37/03-03C 107 Elm ~~STREET~~ AVENUE
(Takoma Park Historic District)

SUBJECT: Historic Area Work Permit 37/3-03C

HISTORIC PRESERVATION COMMISSION STAFF REPORT

Address:	107 Elm Avenue	Meeting Date:	01/22/03
Applicant:	Don W. & M.M. Harvey	Report Date:	01/15/03
Resource:	Takoma Park Historic District	Public Notice:	01/08/03
Review:	HAWP	Tax Credit:	Partial
Case Number:	37/03-03C	Staff:	Corri Jimenez
PROPOSAL:	Portico installation & window replacement		
RECOMMEND:	Approve with conditions

PROPOSED EAST ELEVATION
107 ELM AVENUE

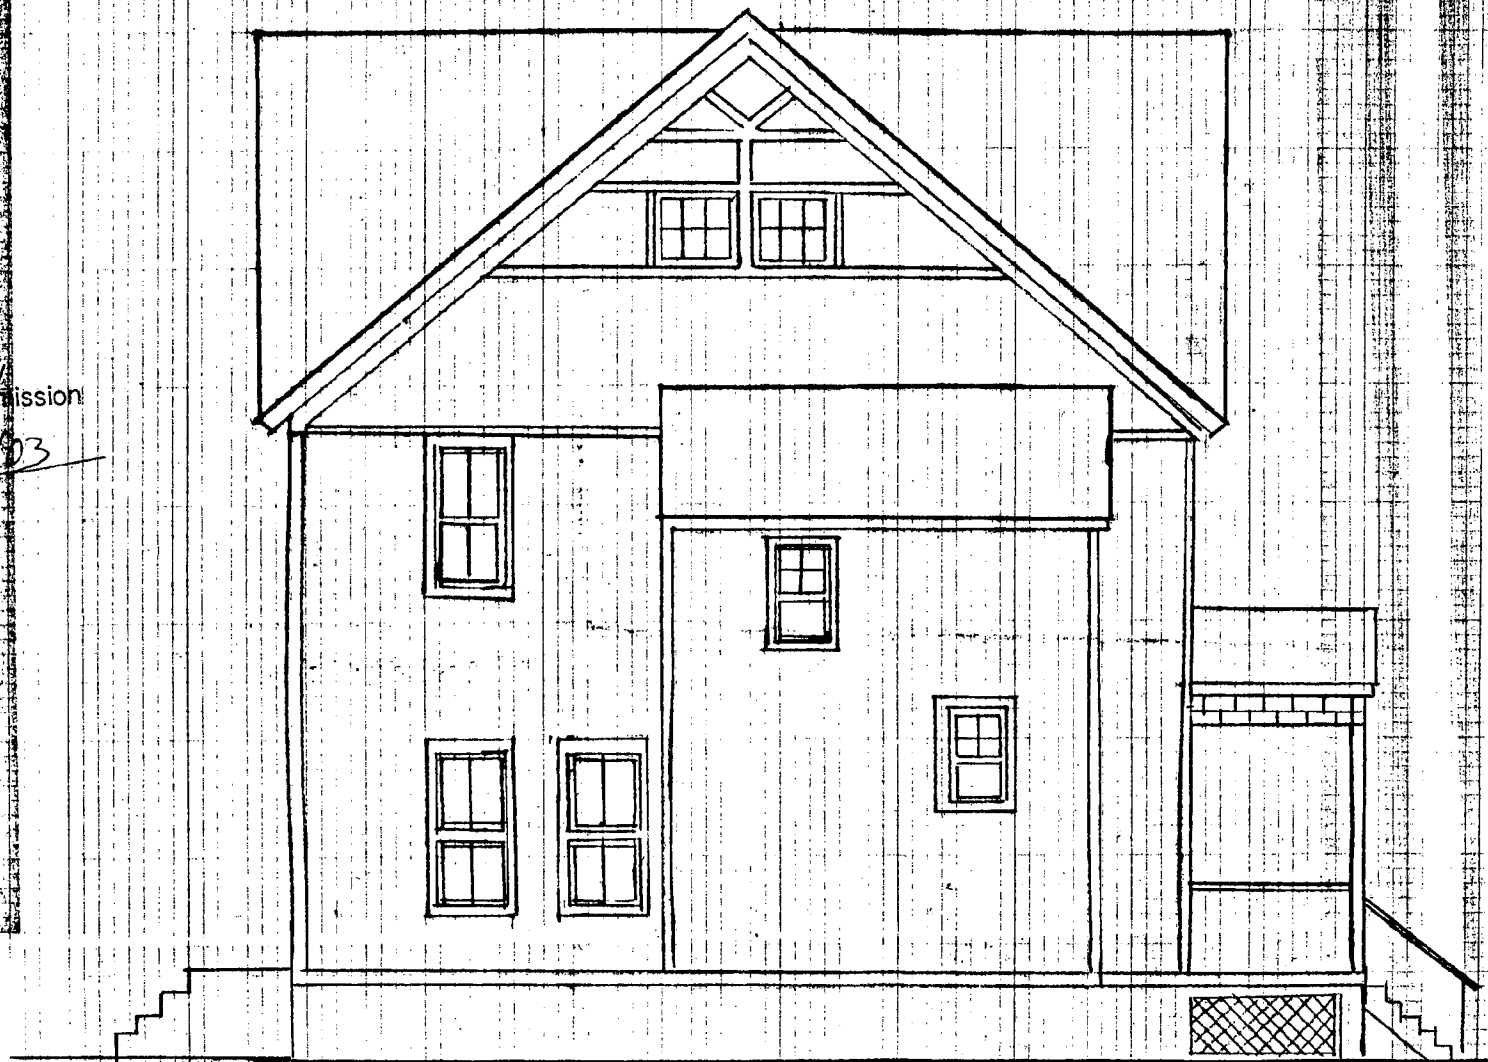
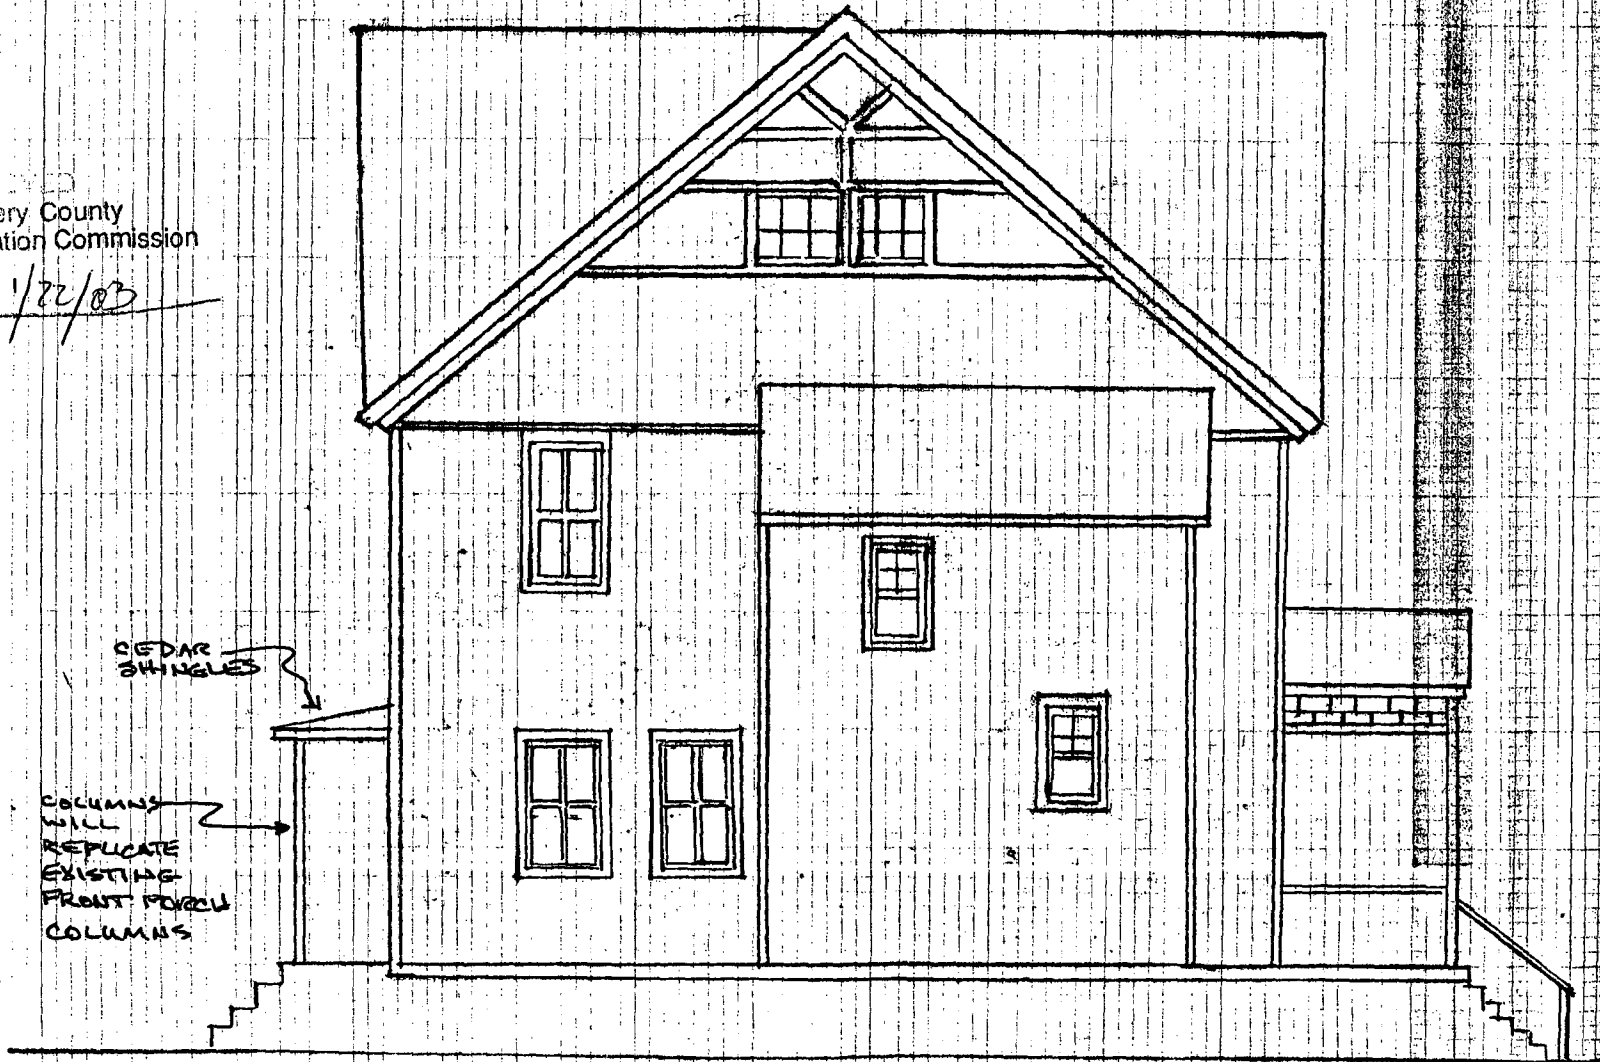
The applicants propose to reconstruct a rear portico on an existing footprint. The addition will be wood frame construction with a ~~composition-asphalt~~ roof and columns that replicate the front porch (see Circle 9). The original portico's roofline is evident, and the new construction will abut this on an existing footprint (see Circle 11).

wood, cedar shingles - Correction

Staff approves as well as encourages the reconstruction of the rear portico and finds the design compatible with the rest of the house, which is a feature that is just obviously missing from this elevation.

1. The replacement windows will be 2/2 wood, double hung and be true-divided lites. Staff would encourage that the old windows be kept on site. Staff would also like to recommend that the applicant try to match the original mullion profile in the window, if possible.

PROPOSED EAST ELEVATION
107 ELM AVENUE

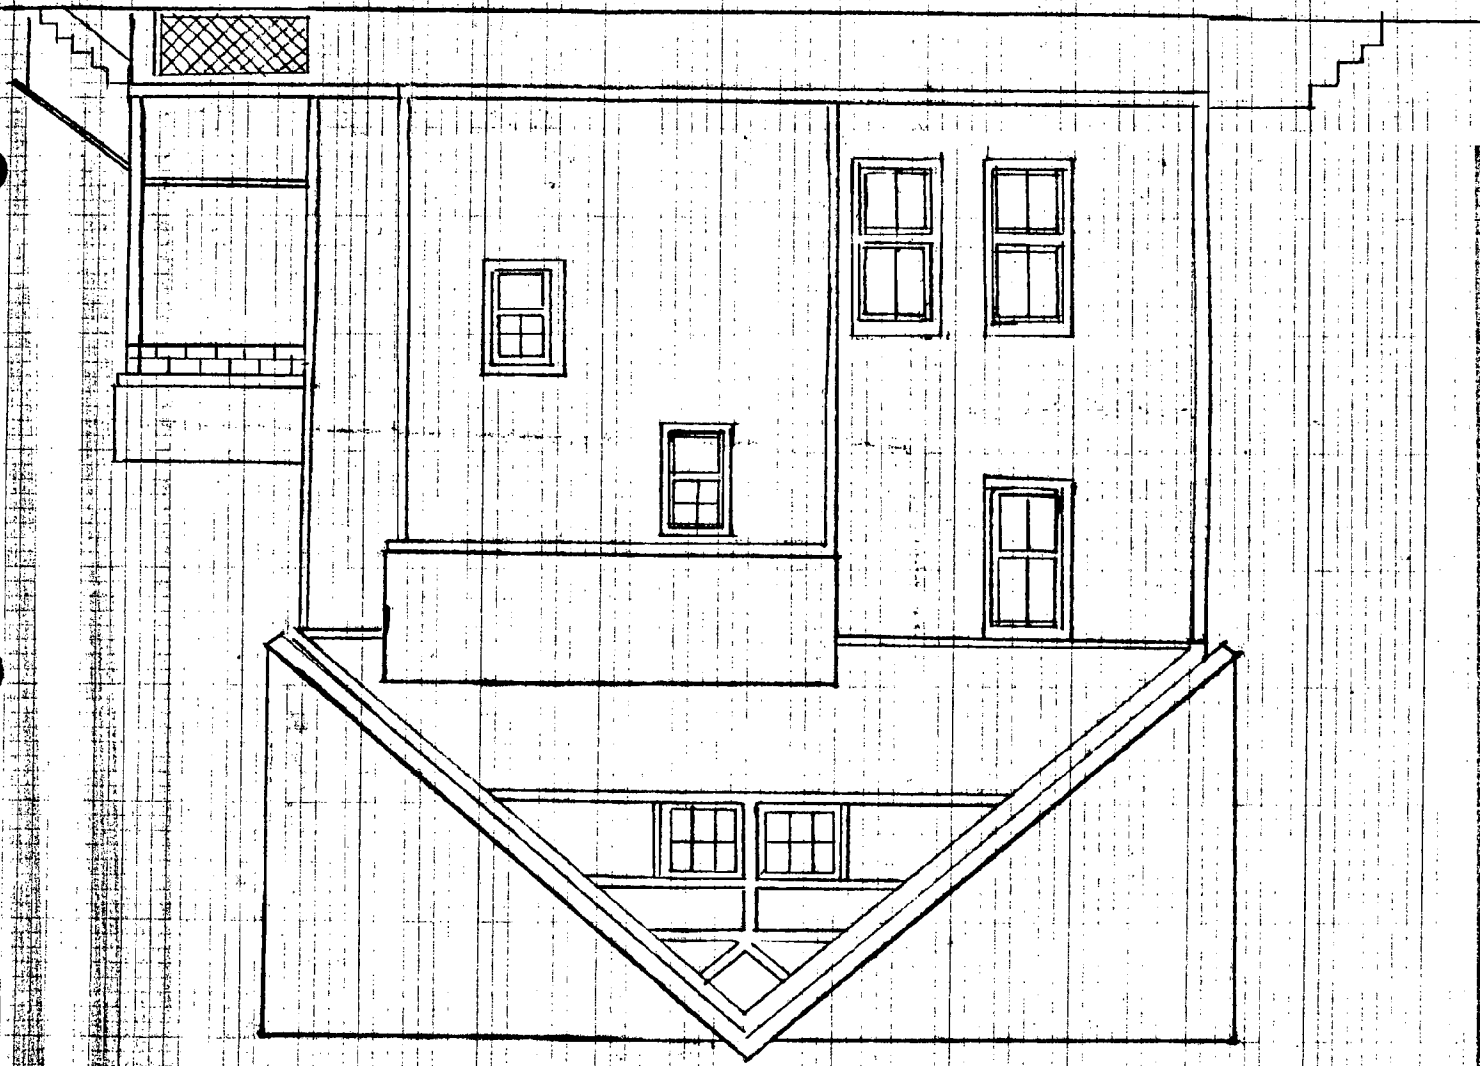
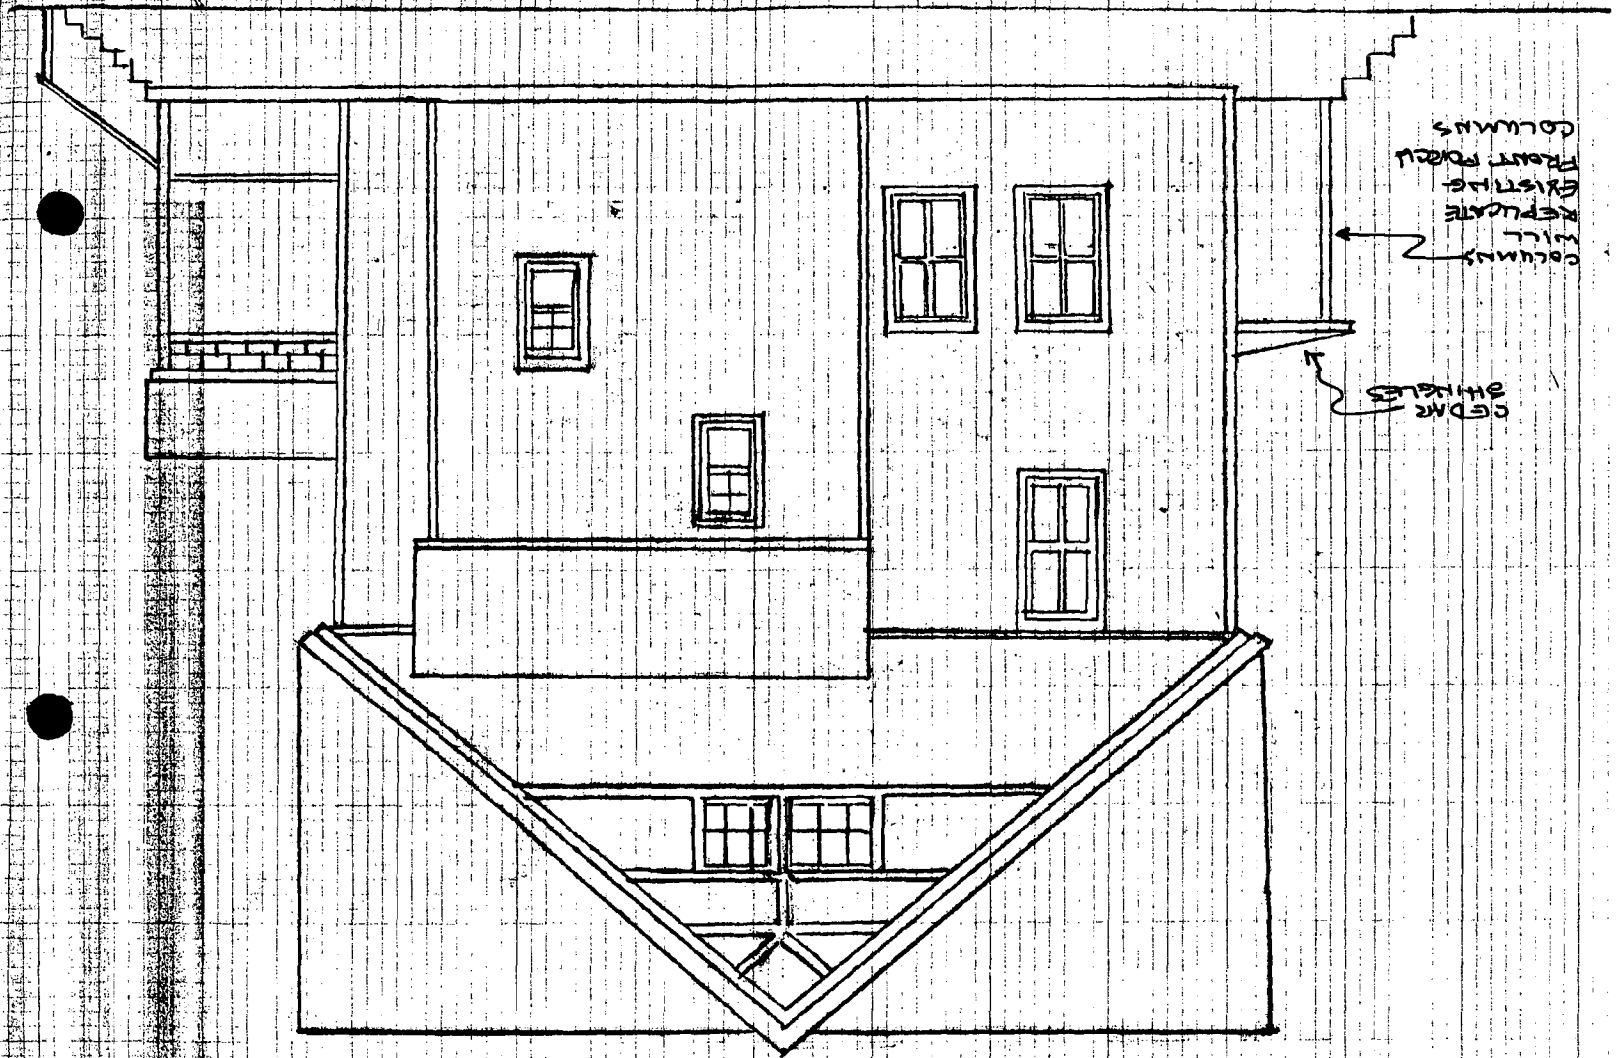
COLUMNS
WILL
REPLICATE
EXISTING
FRONT PORCH
COLUMNS

CEDAR
SHINGLES

PHOTO OF BACK DOOR
SHOWING FLASHING FOR
ROOF EMBEDDED IN
STUCCO WALL.

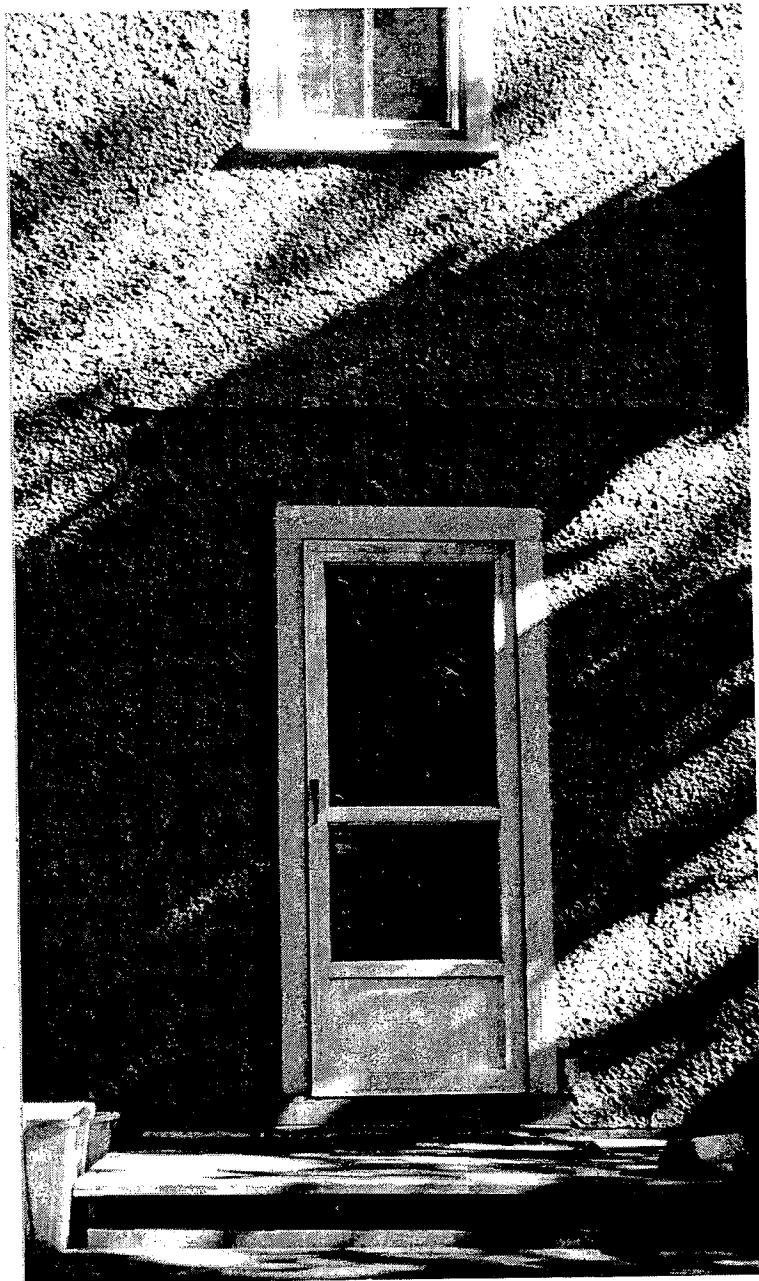
SHED ROOF OF EXISTING
WIDTH OF FLASHING WILL
BE ATTACHED AT THIS
POINT.

SECOND PHOTO OF WINDOWS TAKEN FROM
SIDEWALK ON EAST SIDE OF HOUSE.
STORM WINDOWS WILL BE REMOVED WHEN
EXISTING WINDOWS ARE REPLACED.
(SMALL WINDOWS TO RIGHT WILL REMAIN AS EXIST)

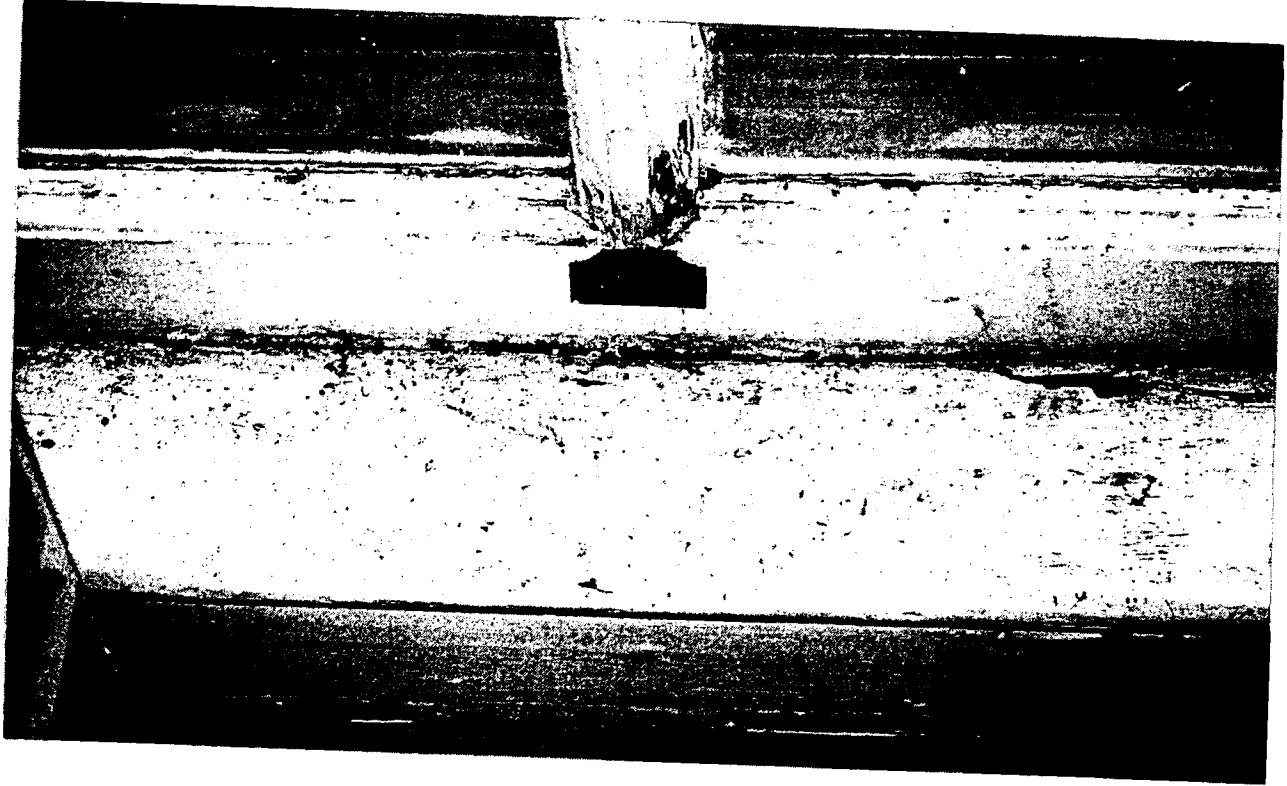
In regards to the windows, the HPC typically does not permit windows for outstanding resources to be replaced. Windows are regarded as essential parts of the architectural fabric of a building. The goal of historic preservation is not only to keep the general exterior appearance of the historic building intact, but also to preserve original building materials. In addition, the Secretary of Interior's Standards state windows should be repaired rather than replaced, regardless of their conditions, which is supported with guidelines for property owners (see Circle 17-24).

Because these windows are located behind a fence and two-story, side shed roof addition, they are not highly visible from the public right-of-way. One of these windows apparently is not original to the house, though is contemporary and probably was added 20-30 years after construction of the house (see Circle 25). Staff recommends to approve of this project with the condition that the replacement windows be 2/2 wood true-divided lites with historic replicated mullions. In addition, staff would like to ask that the applicants store on site in a safe place the removed windows because they are attractive original windows and may have a use in the future.

1. The replacement windows will be 2/2 wood, double hung and be true-divided lites. Staff would encourage that the old windows be kept on site. Staff would also like to recommend that the applicant try to match the original mullion profile in the window, if possible.
